Prairie Point Master Plant List

1st SUBMITTAL
JASON IGO
jigo@auroragov.org

PRAIRIE POINT WEST ISP

LANDSCAPE NOTES

LN.1

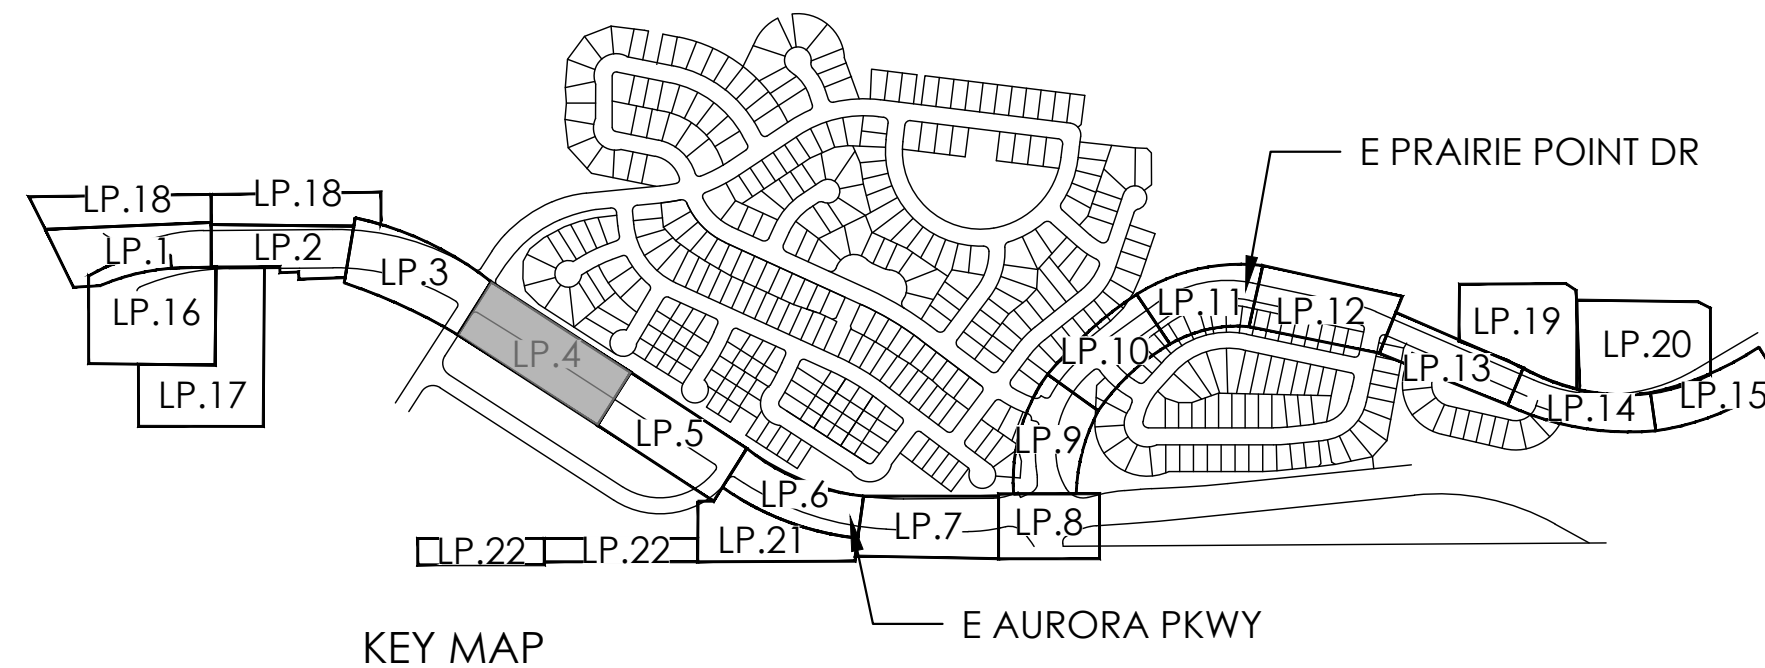
Add note:
Landscape cobble in median shall follow COA STD M1.3

Response:
Noted.

DATE: 03/10/2025
JOB NO: 12187.61
LP.4
32 of 53

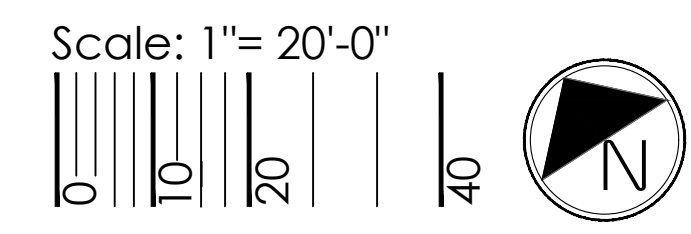
Cobble in the median doesn't have this pattern. Sheet 33 shows this as Rock mulch. Update legend and possibly plans since this is confusing.

Response: Hatch and plans were updated.

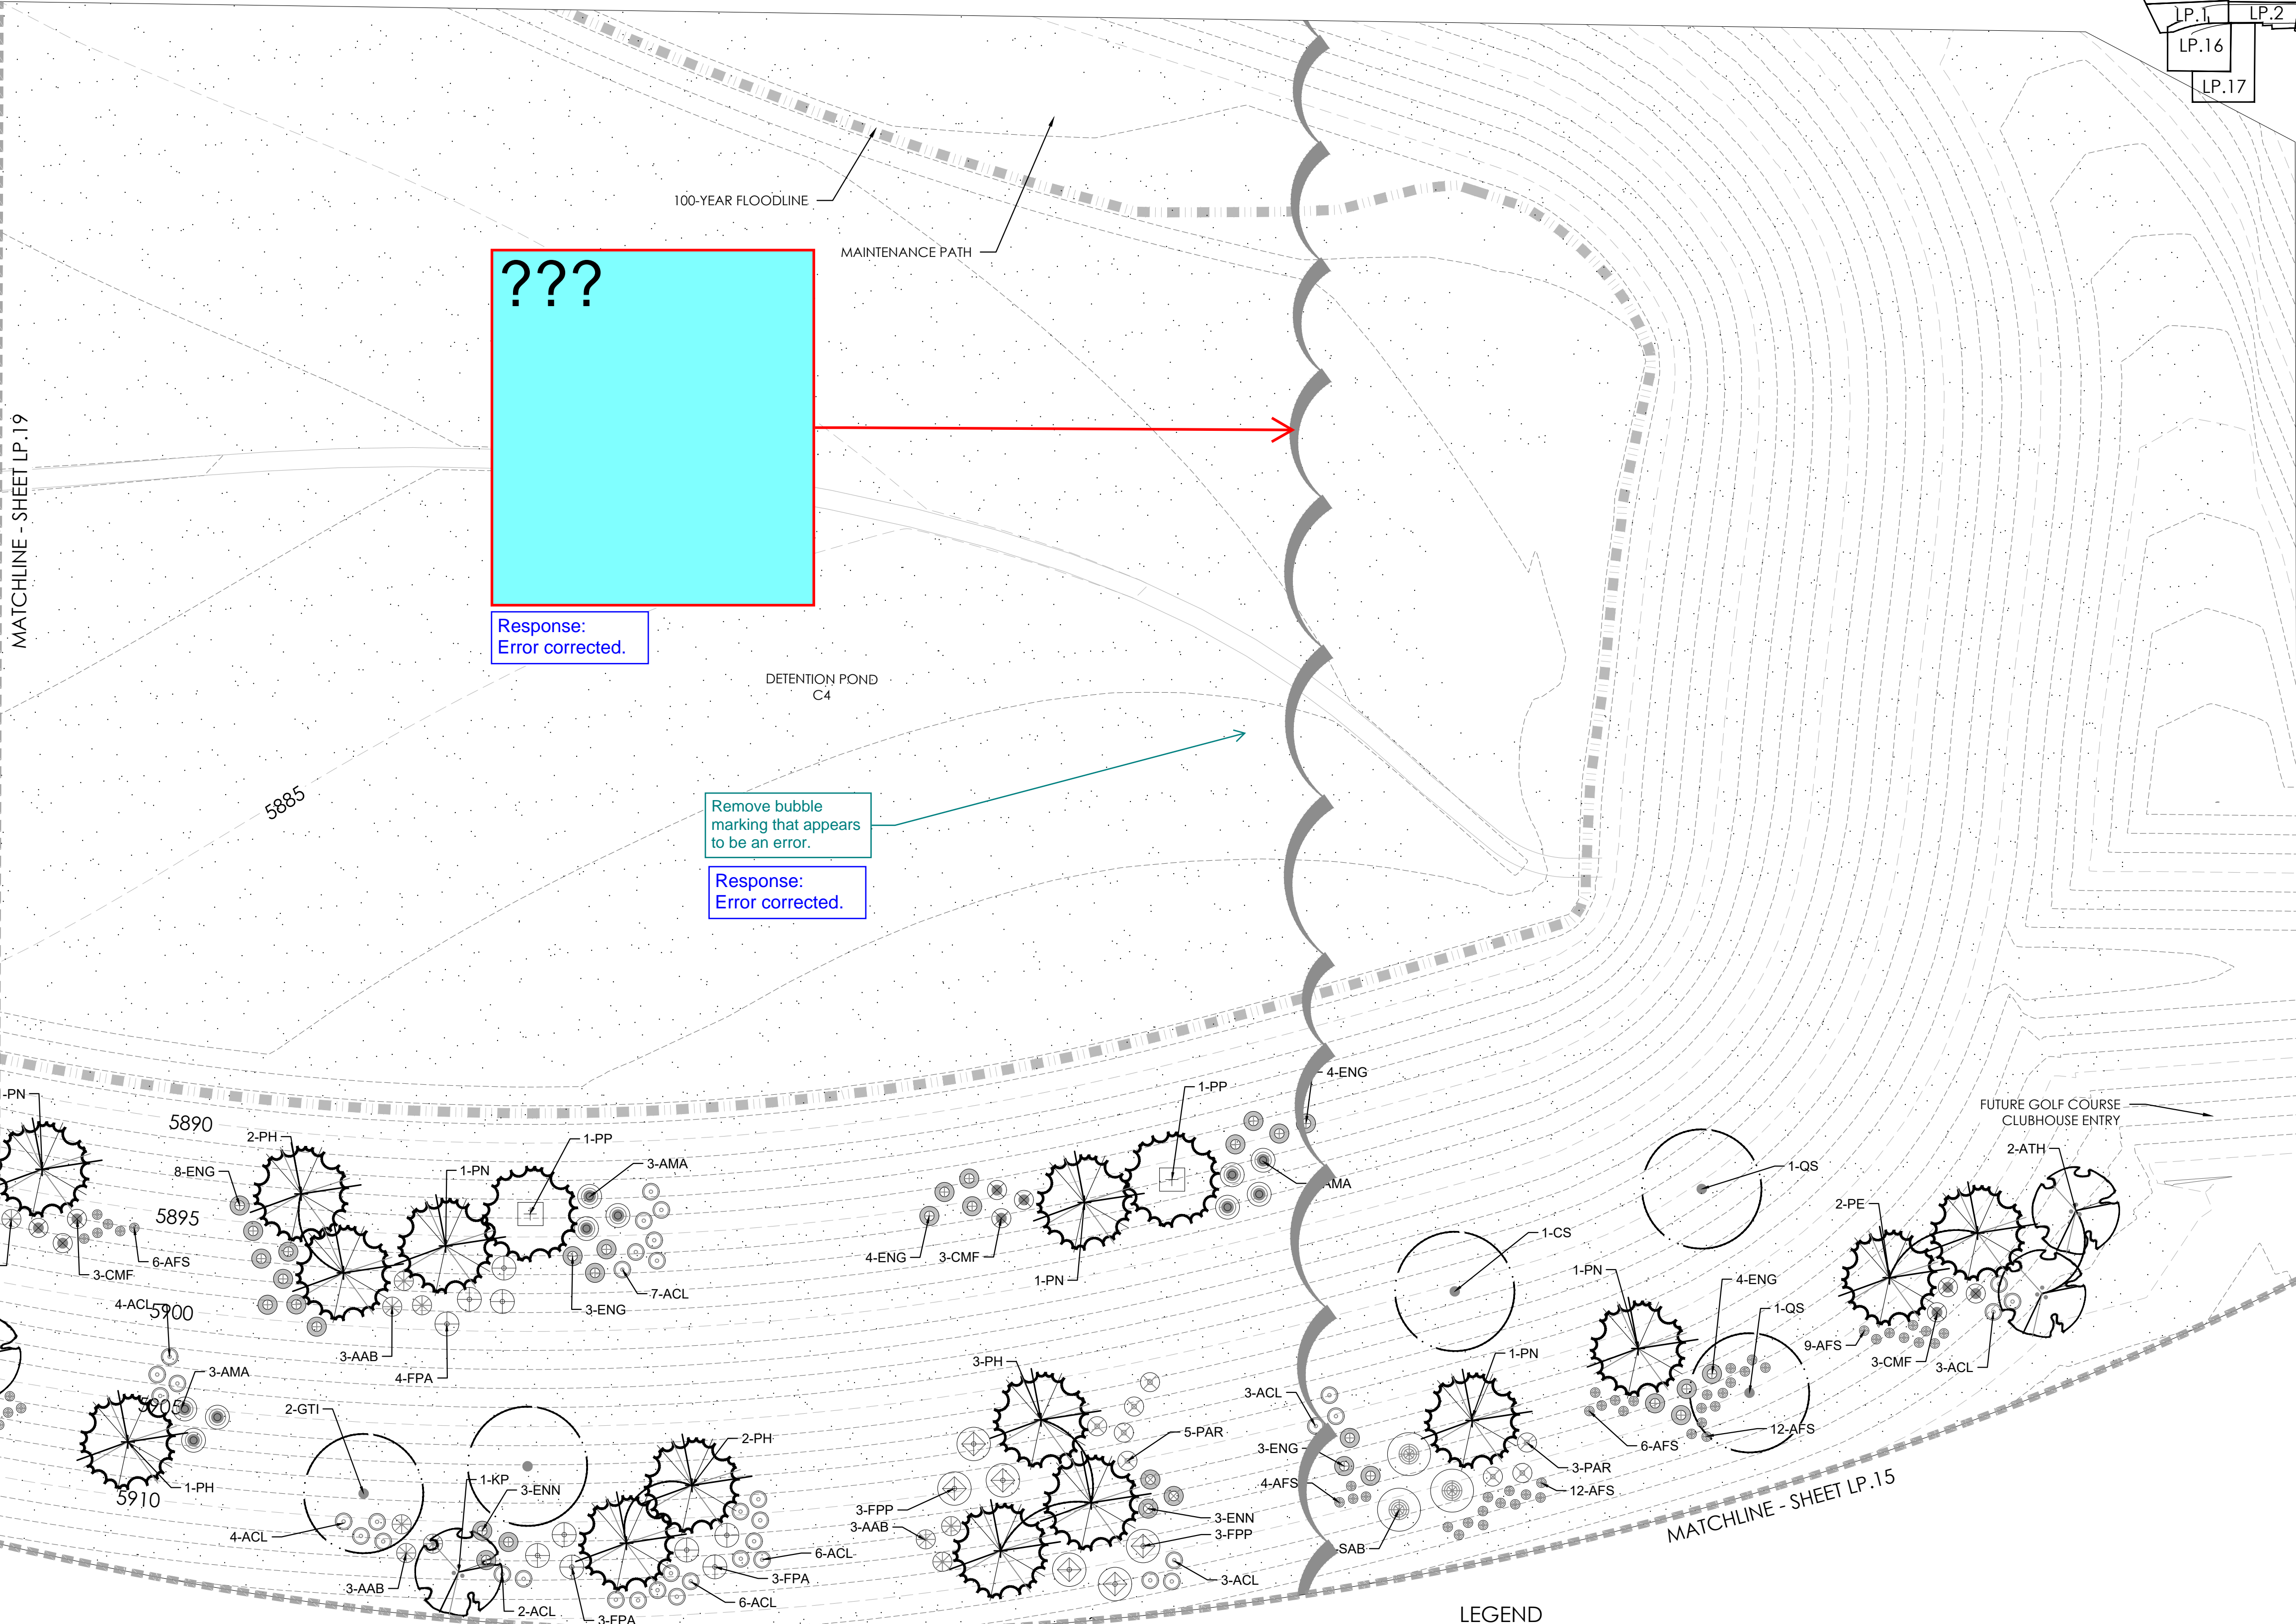
???

Remove bubble
marking that appears
to be an error.

Response:
Error corrected.

Response:
Error corrected.
